BYRON SHIRE FLOODPLAIN RISK MANAGEMENT COMMITTEE MEETING

Report No. 4.1 North Byron Floodplain Risk Management Study and Plan

TO: James Flockton
FROM: Ella Harrison
DATE: 1 March 2018
SUBJECT: North Byron FRMS&P – Draft Hydrologic and Hydraulic Model Review
PROJECT NUMBER: 117098

TO: James Flockton
FROM: Ella Harrison
DATE: 1 March 2018
SUBJECT: North Byron FRMS&P – Model Update
PROJECT NUMBER: 117098

Figure 2: Sherry's Bridge model extension

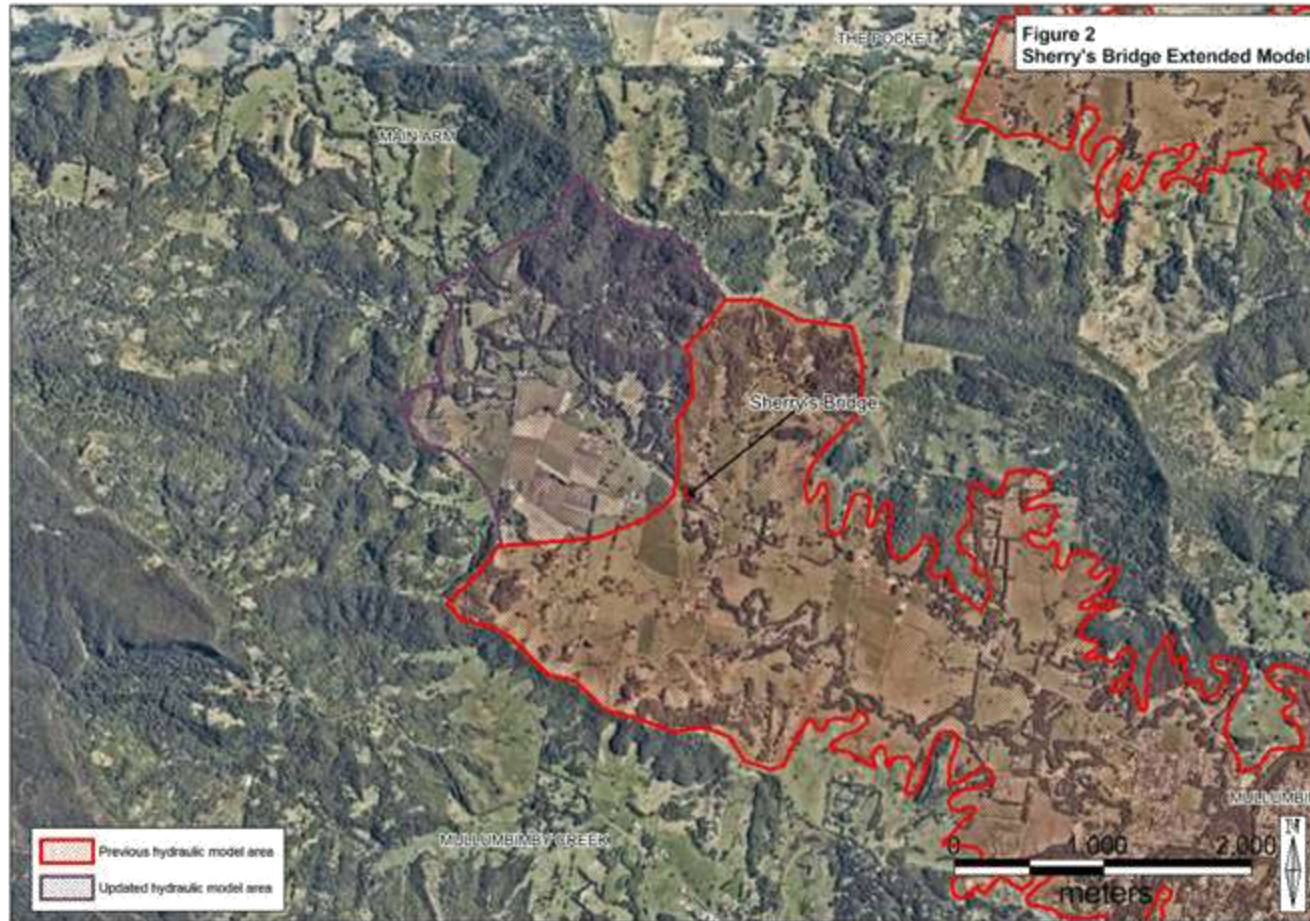
To better represent the flood behaviour around Sherry's Bridge, the hydraulic model has been extended 2.1km upstream of Sherry's Bridge (Main Arm). Figure 2 shows the previous and the updated model extend.

Figure 3: Yeilgun Creek model extension

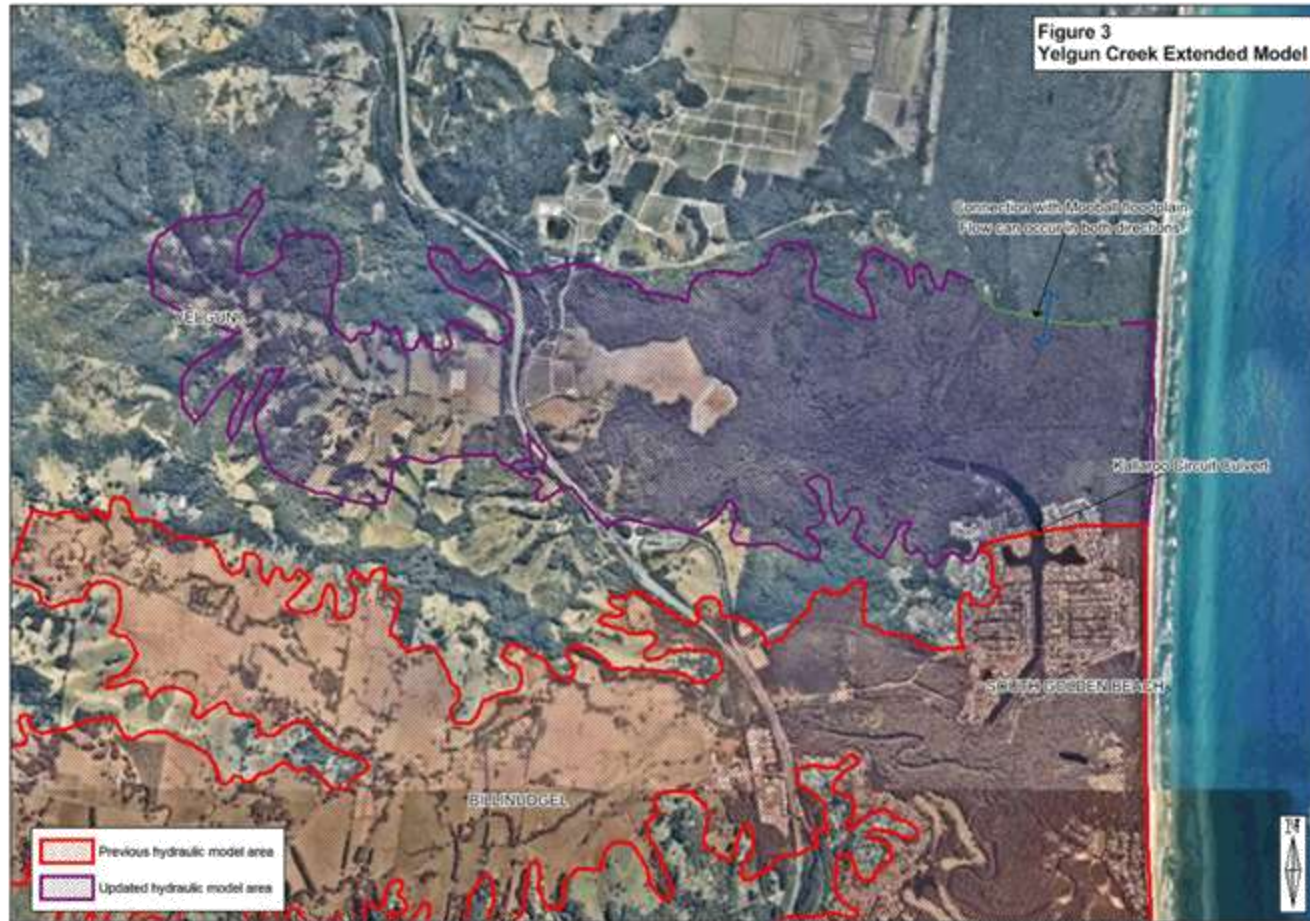
The hydraulic model has been extended from upstream of Kallaroo Circuit in South Golden Beach to Yelgun. Hydraulic structures such as culverts under the Pacific Motorway and the Railway have also been included in the model. Figure 3 shows the previous and the updated model extend.
